BUILDING PERMIT

Permit Number: 081391

This is to certify that NICO REAL ESTATE LLC / Benchmark
has permission to Amendment to permit# 08105 include ramp, structural support for HVAC unit, add storage above break room
add exterior metal facade, add interior stairs
AT 691 CONGRESS ST 047 C033001

SK-13

C-1.1

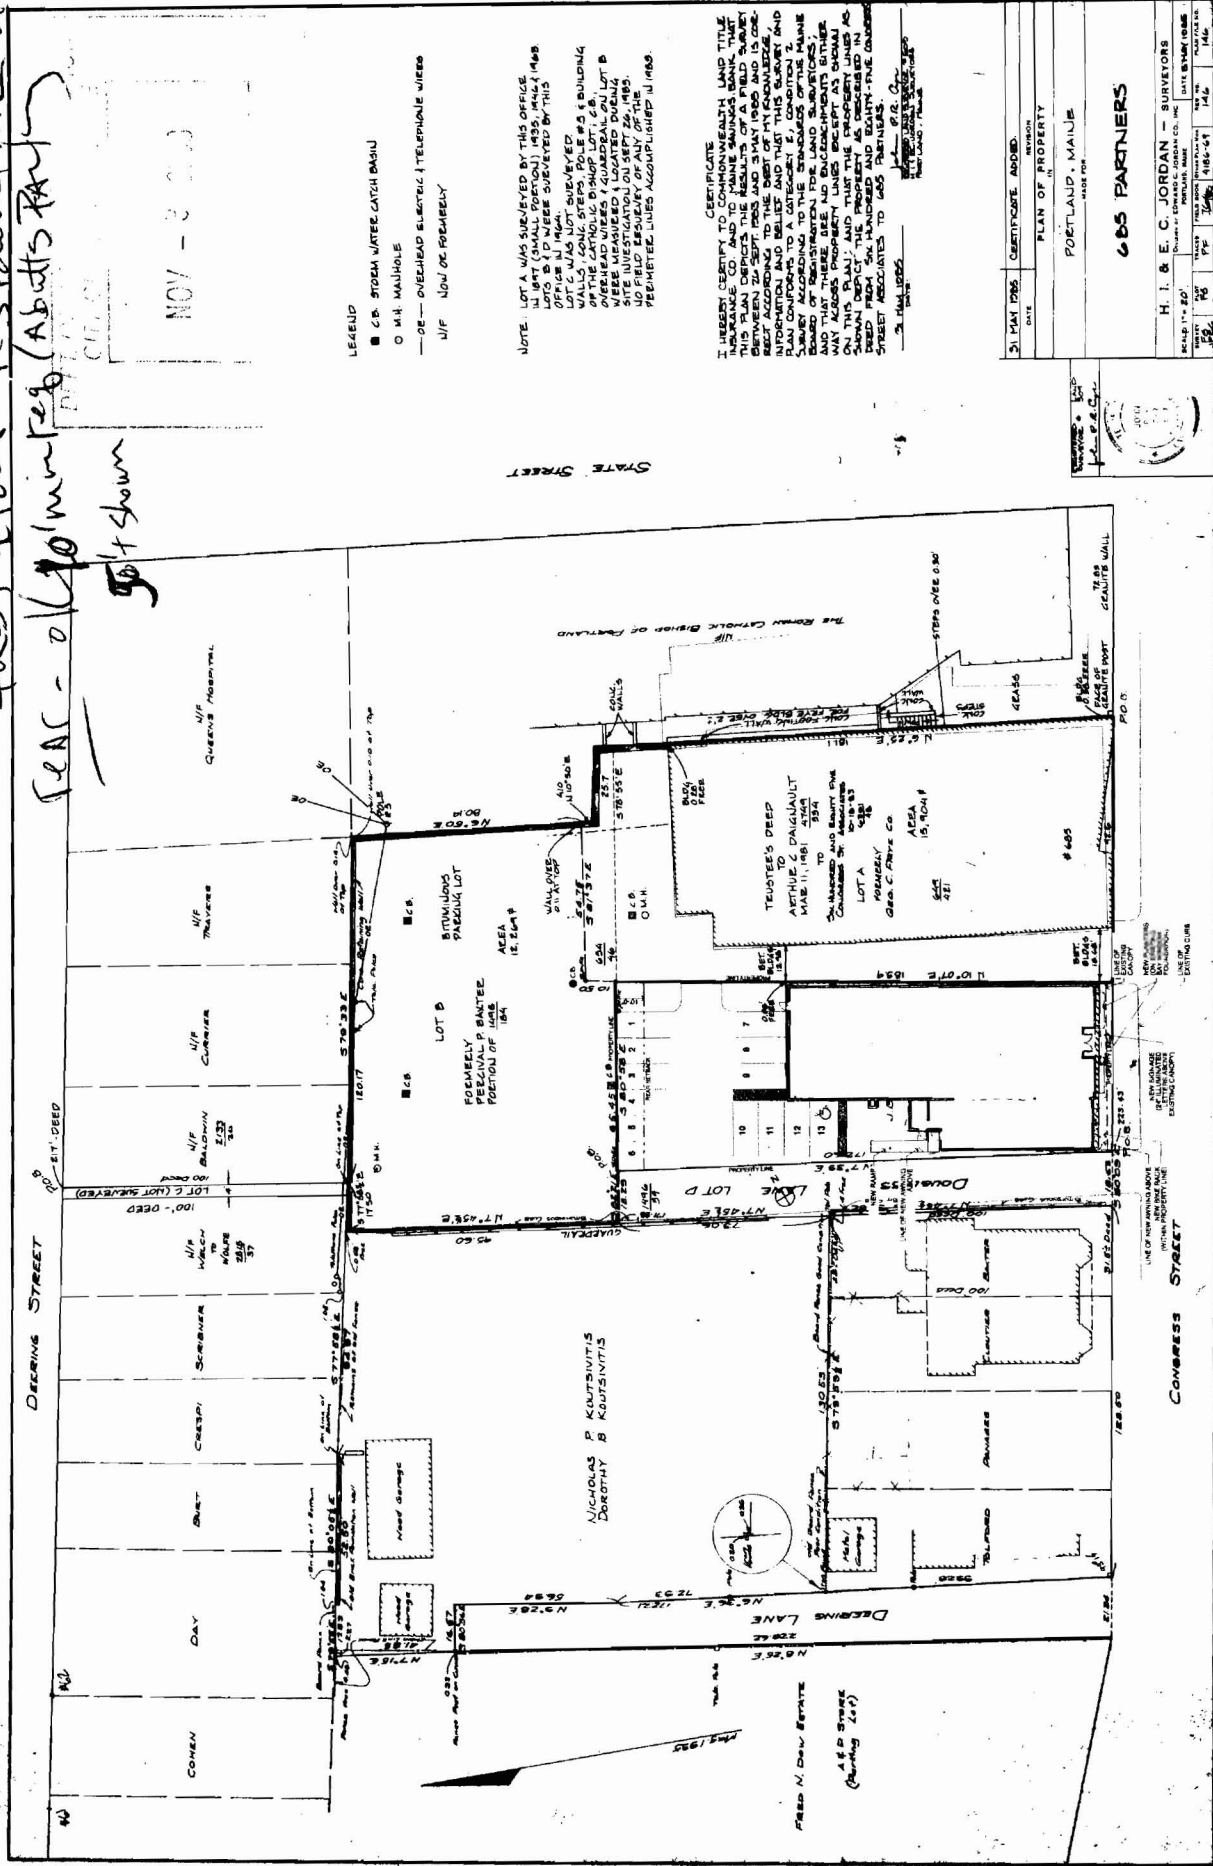
10/30/2008-mes: The front staff did not get a site plan with this application. There is a new exterior ramp addition being added. Applicant had the wrong zone on other drawings. This property is located within a B-2b Zone not a B-1b zone. Left a message with Richard Egan - reminded him that he needs a site plan review or an exemption from it from Planning.

11/4/2008-mes: on 11/3/08 I received a plot plan for the new work (ramp & new facade extension). I reminded Jessie Thompson that at a minimum a site plan exemption is required from Planning - Barbara is aware of the work. HOLD FOR SITE PLAN EXEMPTION

11/26/2008-gg: received granted site exemption as of 11/25/08. /gg filed with permit (Chris)

DRAWING: COVER SHEET

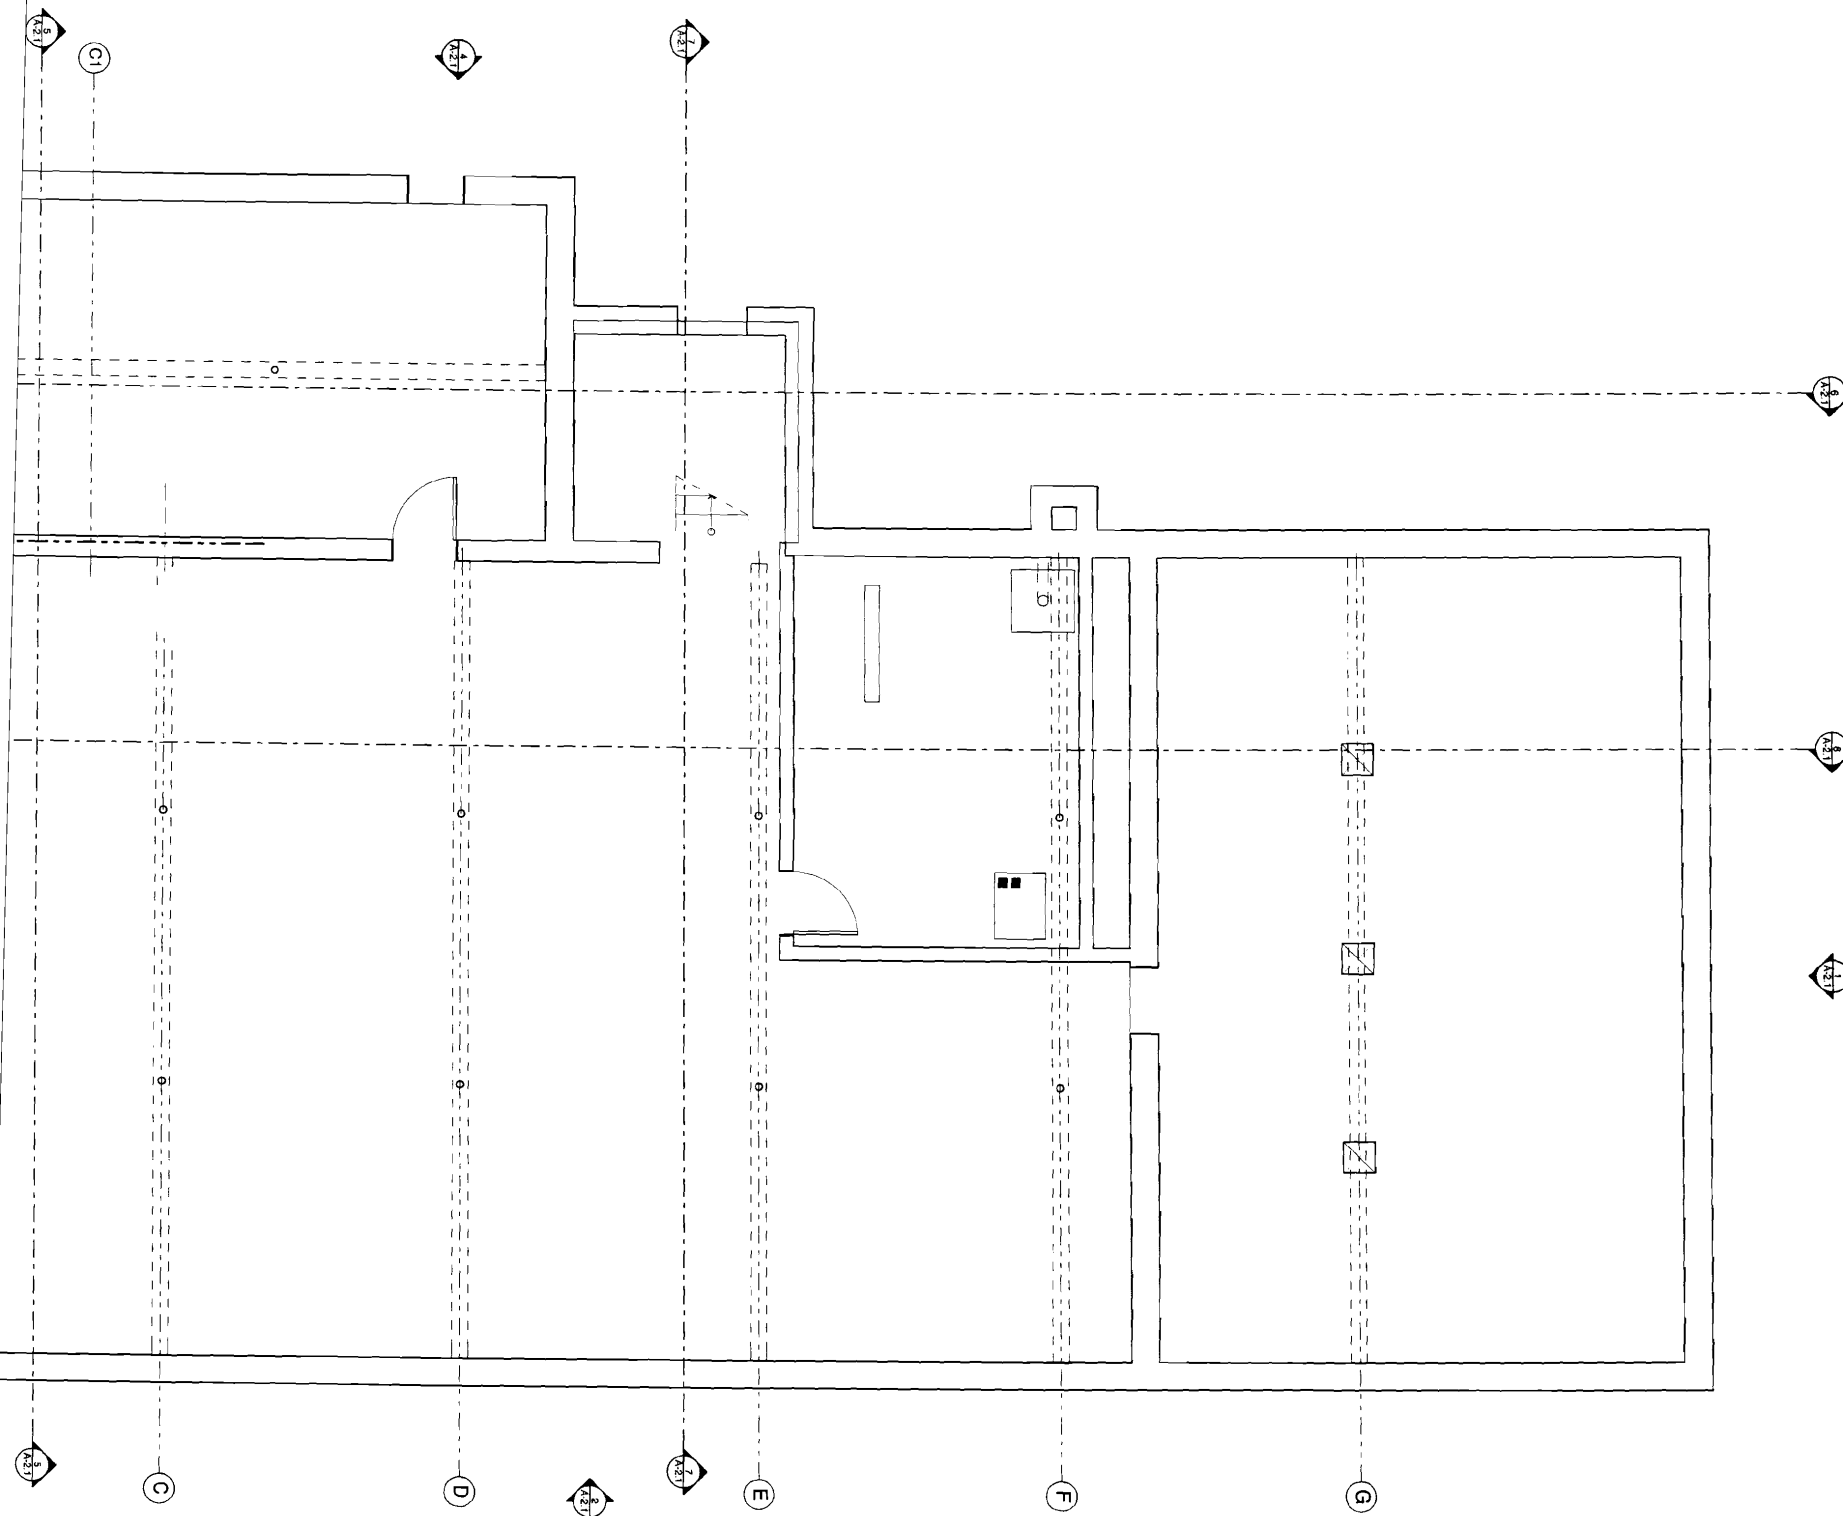
B-2b
See revised
received by
e-mail
11/3/08
